Amendments to the Drawings:

REMARKS

The Office Action dated November 15, 2005 has been received and reviewed by the applicant. Claims 1 is amended and claims 21-30 are new. Claims 1-7 stand rejected.

Fig. 3b (Prior Art)

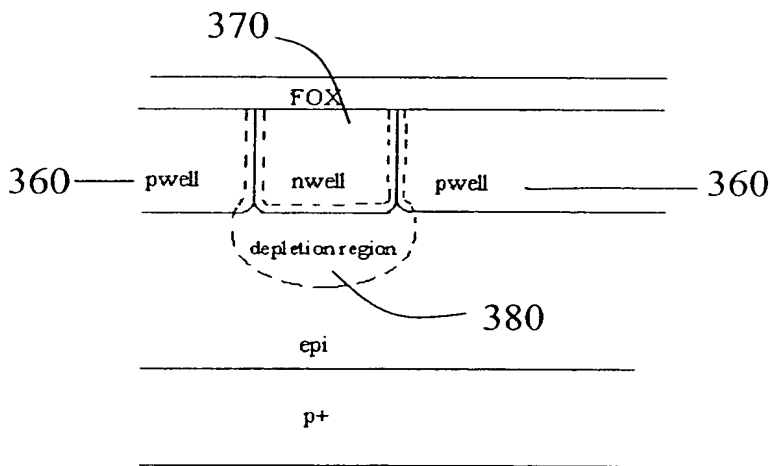
Figures 3a-3b should be designated by a legend such as --Prior Art-- because only that which is old is illustrated. Corrected drawings in compliance with 37 CFR 1.121(d) are attached.

← added
per the
Examiners
request
